RA-22-0089

Subject: Response to Request for Additional Information (RAI) Regarding Application to Revise Technical Specification 3.7.7, "Low Pressure Service Water (LPSW) System," to Extend the Completion Time for One Required Inoperable LPSW Pump on a Temporary Basis

RESPONSE TO REQUEST FOR ADDITIONAL INFORMATION

Figures 1-7 below are provided for Large Cold-Leg Break LOCA scenarios with the LPSW C pump failure assumed at three different times:

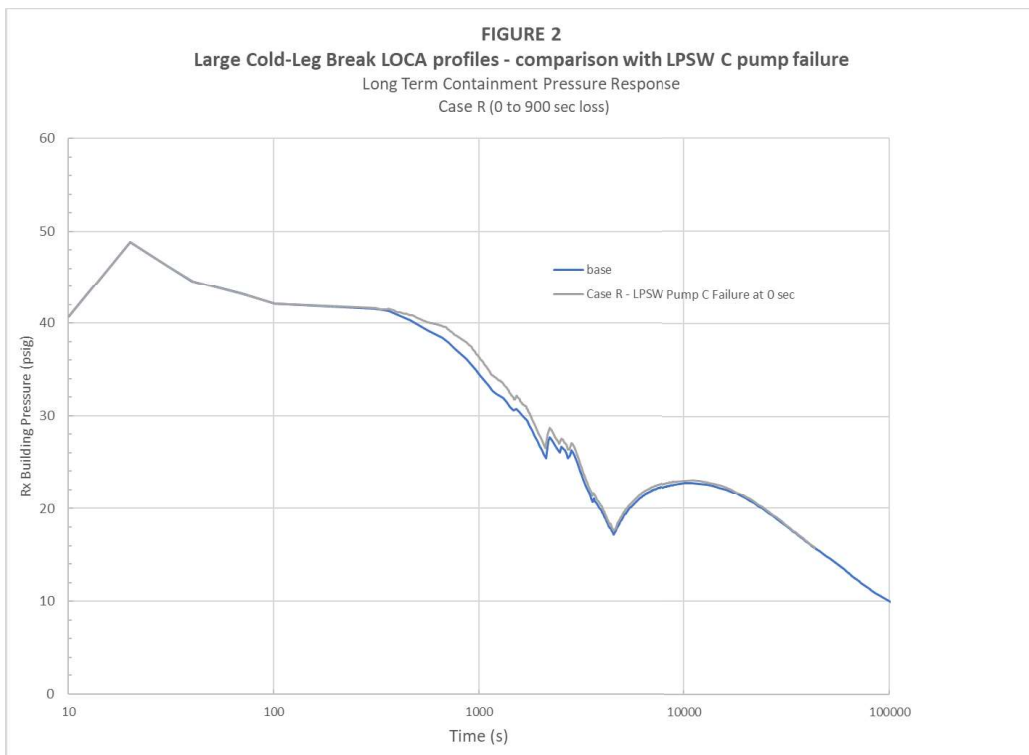
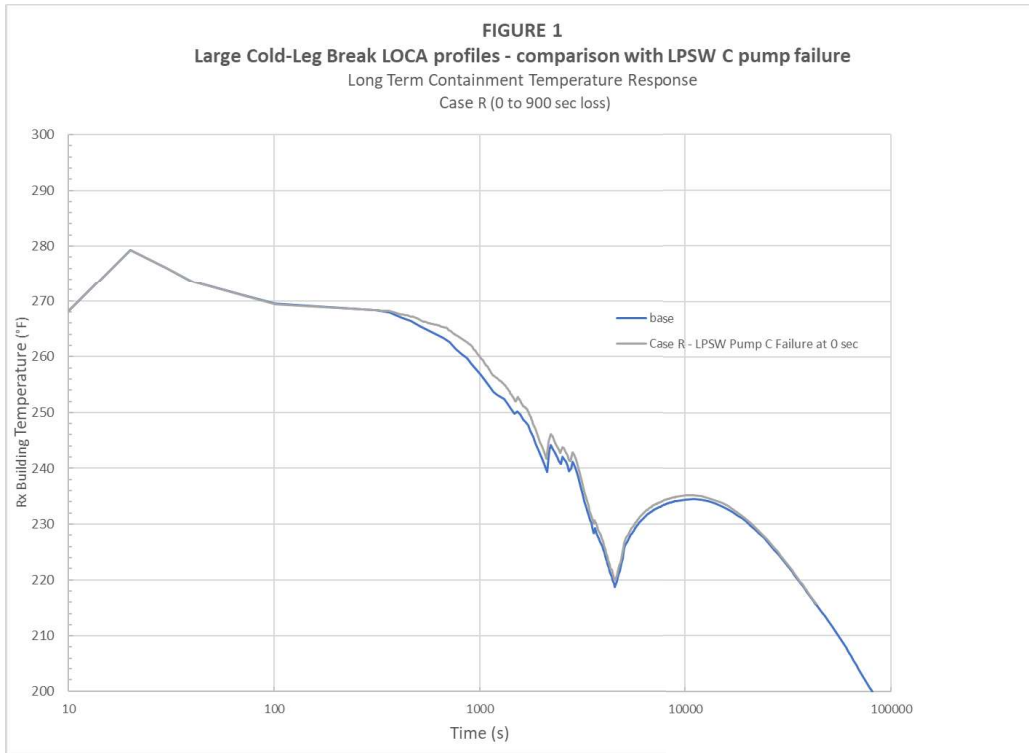
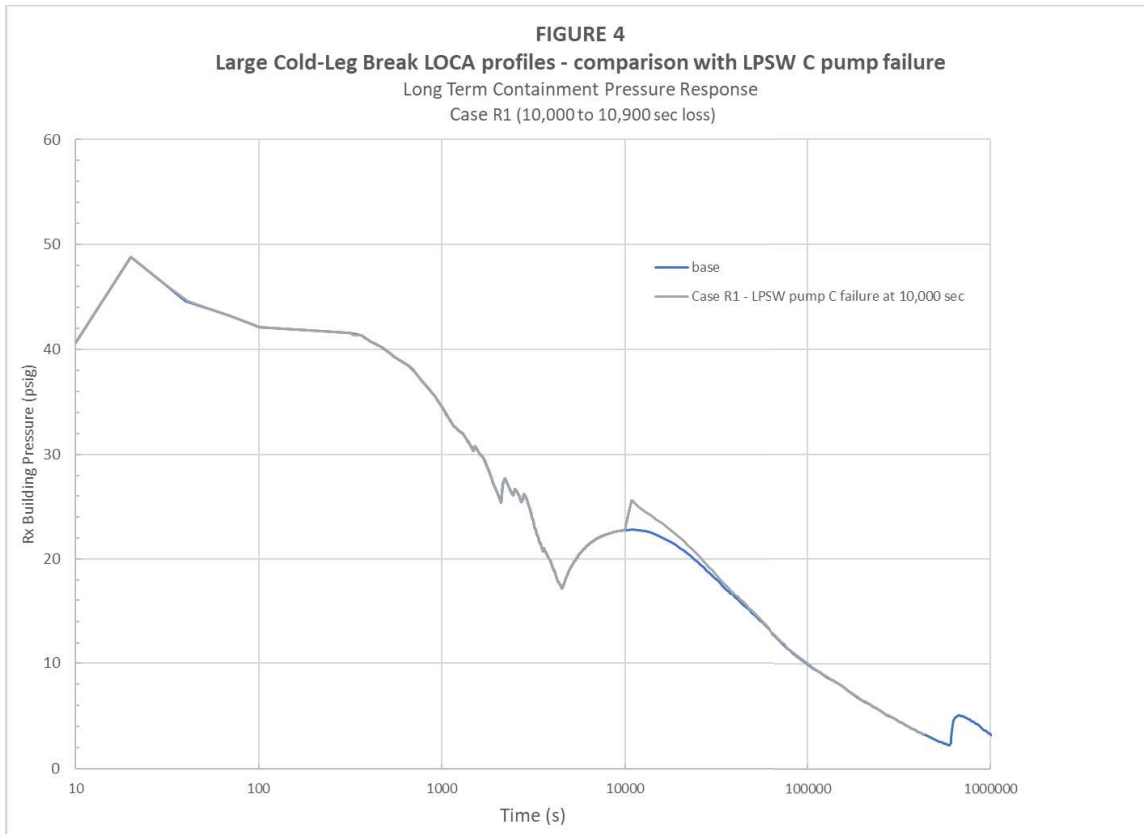
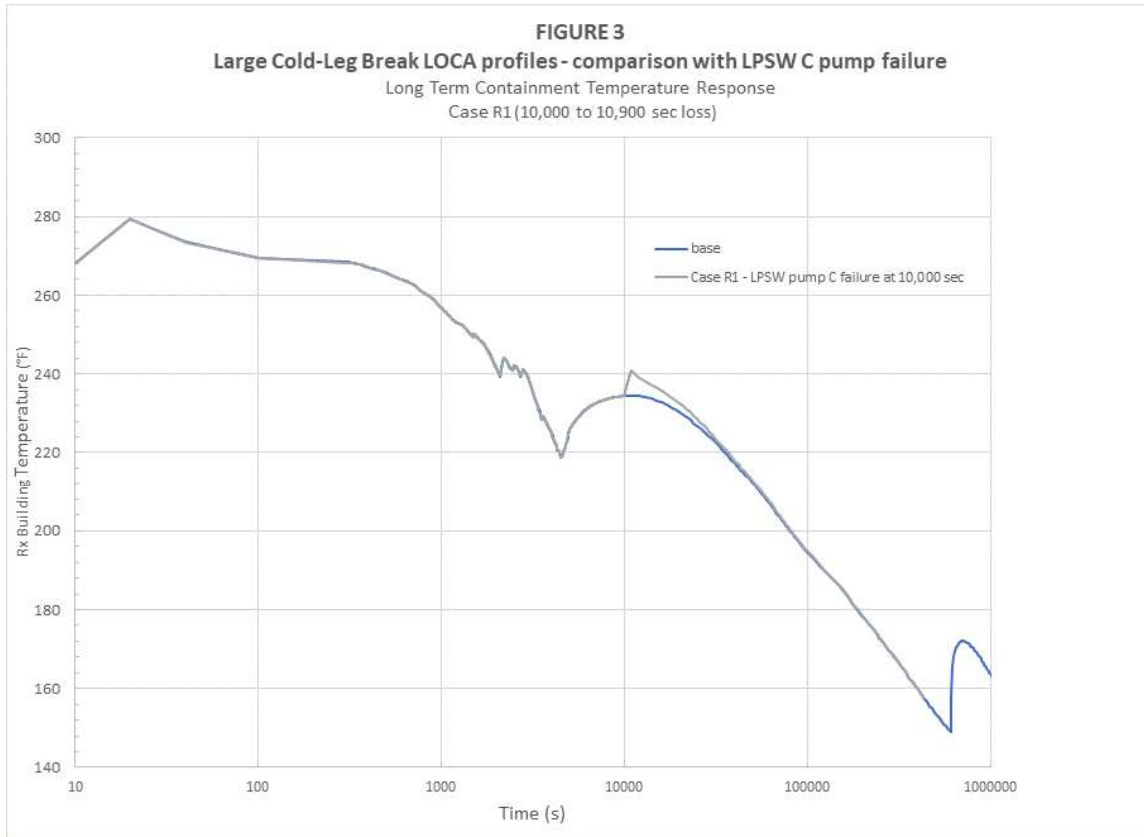
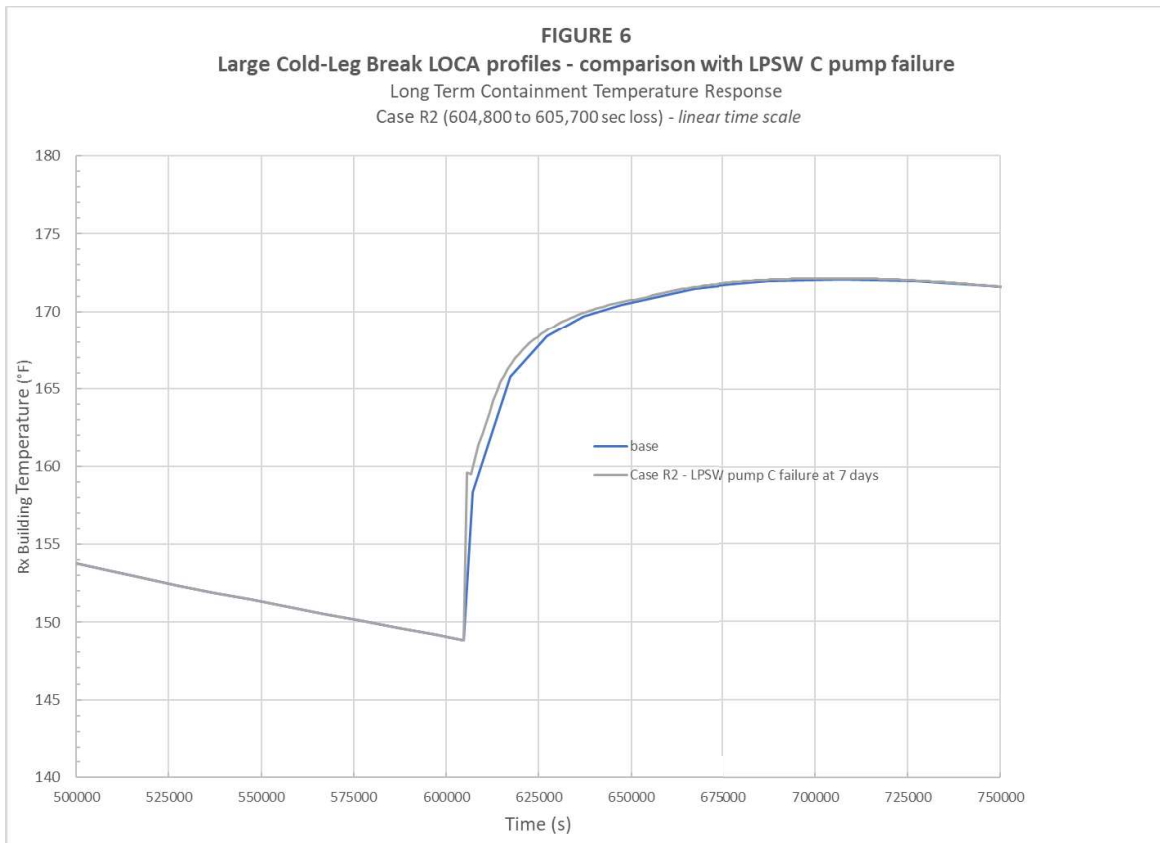
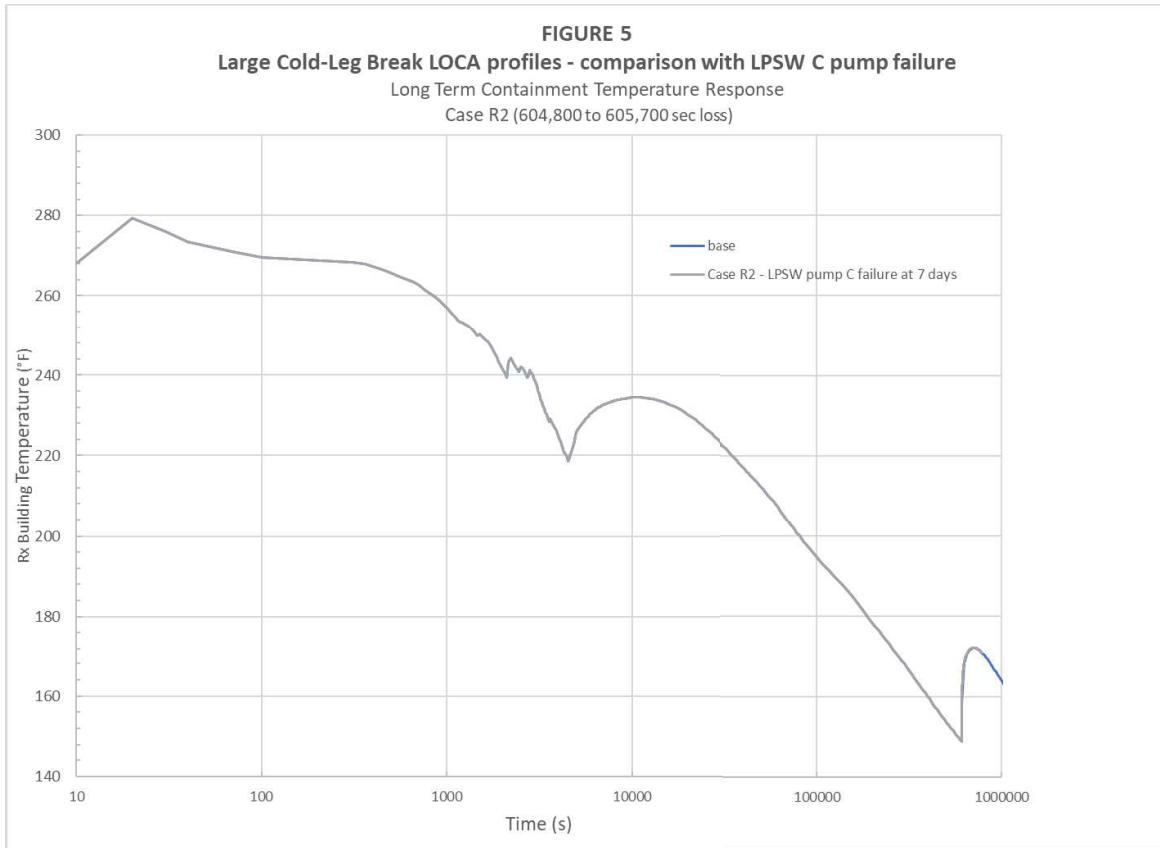
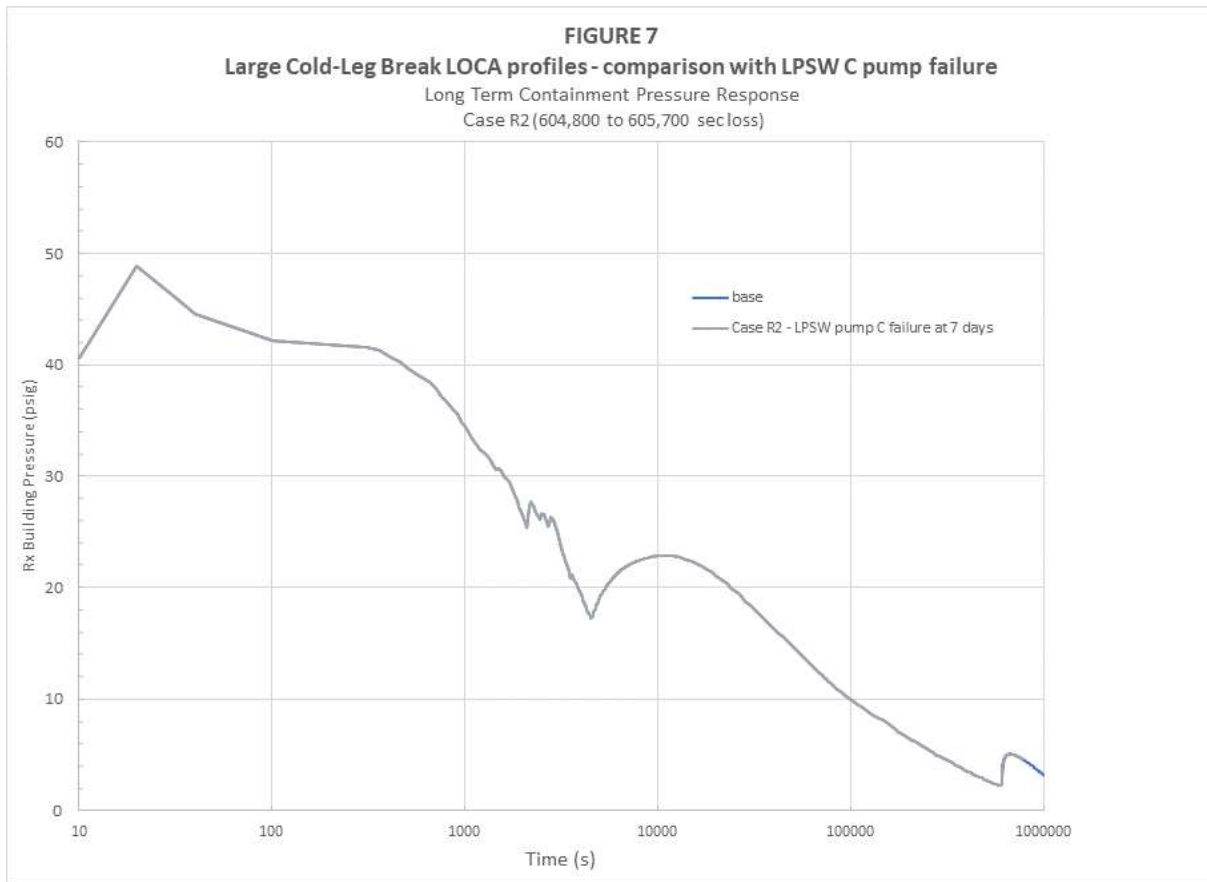
- (b) During the period in response to (a) containment cooling would stop completely. The UFSAR analysis of record (AOR) Figures 6-36 and 6-37 appears to indicate containment pressure and temperature profiles may reverse. With the same analysis inputs and assumptions as in the AOR, provide the containment analysis pressure and temperature profiles, peak pressure, and vapor temperature for the worst-case assuming failure of the LPSW C pump at any time from 0 to 288 hours.

- (c) Confirm that the analysis in (b) shows that the containment peak pressure and peak vapor temperature are bounded by the AOR values in UFSAR Figures 6-36 and 6-37, respectively.

- 1) Case R – LPSW C pump failure at t=0
- 2) Case R1 – LPSW C pump failure at t=10,000 seconds. This is at the approximate time when Reactor Building (RB) pressure / vapor temperature trends have reached their peak values after sump recirculation mode has been entered.
- 3) Case R2 – LPSW C pump failure assumed at t=7 days. For the AOR, it is assumed that RBS pumps are terminated at this point in the transient. The termination of those spray pumps causes a decrease in steam condensation in the RB atmosphere, leading to a short duration where RB vapor temperatures increase.

In all Figures presented, the cases with postulated LPSW C pump failures are overlaid with the AOR results (UFSAR Figures 6-36 and 6-37). For Case R2, time scales are modified in Figure 6 to facilitate comparison. Also, restoration of LPSW flow to the RBCUs / LPI coolers is assumed to occur 15 minutes after the postulated LPSW C pump failure based on the response to RAI 1(a) above.

For all three cases, the peak pressure and vapor temperature values shown in UFSAR Figures 6-36 and 6-37 are not impacted. This is because these peak values occur early in the transient (about 20 seconds after the LOCA occurs), well before RBCUs are assumed to initiate in the AOR. For Case R with the LPSW C pump failure assumed to occur at t=0, the time delay in restoring LPSW flow to the RBCUs of 15 minutes means that only 10 minutes of RBCU cooling is lost (RBCU initiation is assumed to occur at t=5 minutes in the AOR).

Based on the response to RAI 1(b), it is confirmed that for all cases executed for the 1(b) response, the containment pressure and peak vapor temperature values are bounded by the AOR values shown in UFSAR Figures 6-36 and 6-37.

FIGURE 8
OCONEE NUCLEAR STATION
HOT LEG BREAK ANALYSIS FOR NPSH REQUIREMENTS
INITIAL BUILDING CONDITIONS @ 15.9 PSIA AND 152°F WITH 100% RH
LOSS OF REACTOR BUILDING SPRAY PUMP
RBCU = 120E6 BTU/HR, LPSW = 86.5°F, BWST = 105°F

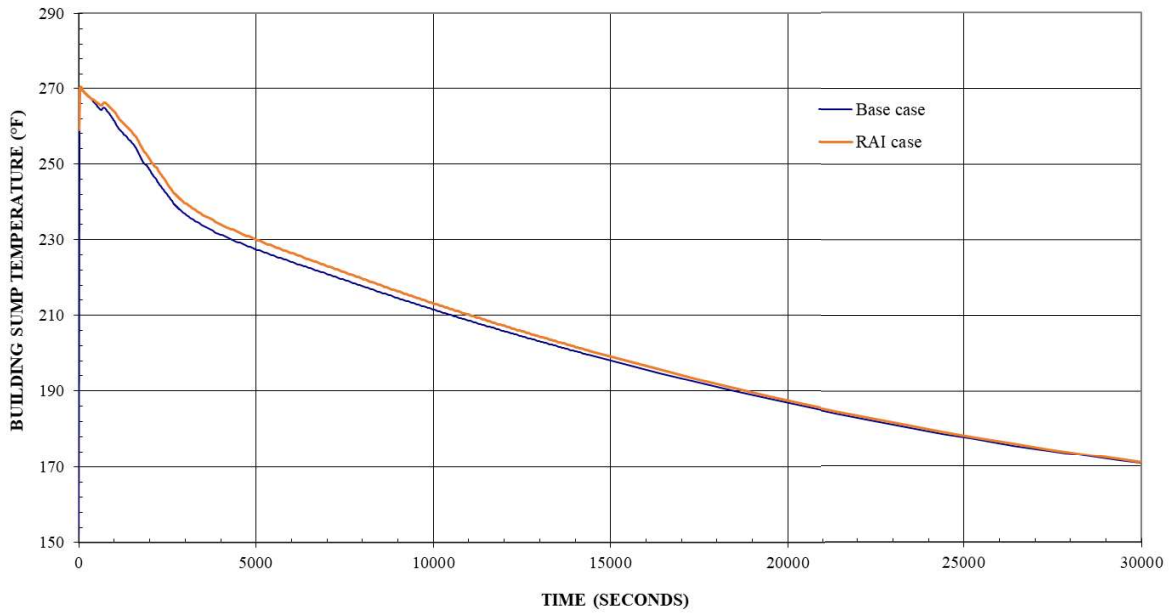
- the peak containment wall temperature based on the peak vapor temperature remains bounded by the AOR containment structural design temperature.
- (f) Due to the absence of LPSW flow to RBCU and LPI coolers for the period in (a) during anytime between 0 to 288 hours, show that the worst-case sump temperature profile remains bounded by the AOR temperature profile. If it is not bounded, please provide the following:

- I. Revised sump temperature profile.
 - II. Available net positive suction head (NPSH) profile(s) for the pumps that draw water from the sump during the LOCA recirculation phase.

The Reactor Building sump temperature results for the large hot-leg break LOCA case are shown in Figure 8. This trend is overlaid from the case without the postulated LPSW C pump failure. The sump temperature difference is small at first, but gets larger until the time of switchover to sump recirculation mode. This difference reaches a maximum value of about 3°F. This difference will start to decrease further into the transient as RBCU/LPI cooling will compensate for the difference. This will allow the sump temperature differences to decrease over time, and for the trends to converge.

At the time when sump recirculation mode is entered (2677 seconds), the sump temperature in the case with the LPSW C pump failure has decreased to 242.3°F. This is about 3°F warmer than the same time in the base case, where the sump temperature is 239.4°F at this time.

Since the sump water temperature is always decreasing once sump recirculation mode is entered (per Figure 8), the limiting point with respect to NPSH calculations (maximum sump temperature) is at the point of switchover when the RBS pumps start to take suction from the sump. Also at this point, RB pressure is at an inflection point where it starts to increase (per Figure 9). Therefore, since it is known that $NPSH_a$ will be at its minimum value at the point when sump recirculation is entered, there are no $NPSH_a$ profiles ($NPSH_a$ as a function of time) developed. The value for $NPSH_a$ is only calculated at the point of switchover to sump recirculation mode.

FIGURE 10
OCONEE NUCLEAR STATION
HOT LEG BREAK ANALYSIS FOR NPSH REQUIREMENTS
INITIAL BUILDING CONDITIONS @ 15.9 PSIA AND 152°F WITH 100% RH
LOSS OF REACTOR BUILDING SPRAY PUMP
RBCU = 120E6 BTU/HR, LPSW = 86.5°F, BWST = 105°F

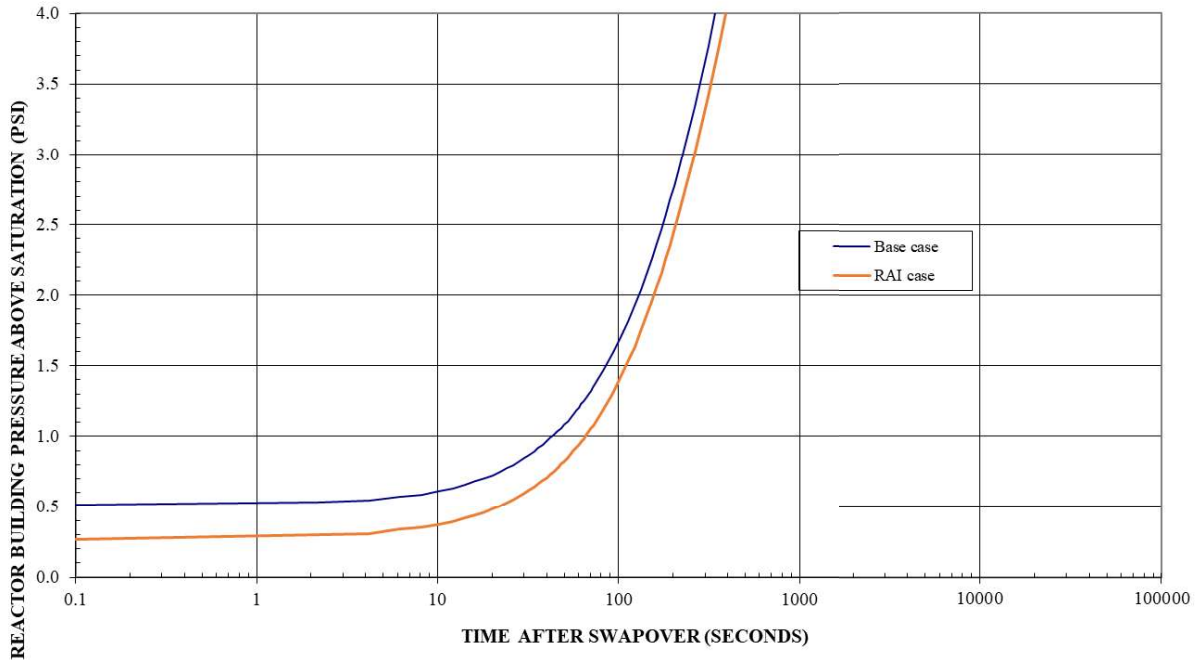
- III. Minimum NPSH margin for the pumps in (ii) and the containment accident pressure (CAP) below the vapor pressure at sump temperature used in calculating this margin.

A profile for the available Reactor Building overpressure (as a function of time after sump recirculation mode is entered) is shown in Figure 10. This trend is overlaid from the case without the postulated LPSW "C" failure. The reduction in overpressure just after switchover to sump recirculation mode is shown in this trend. The amount of available RB overpressure increases to >2 psi within several minutes.
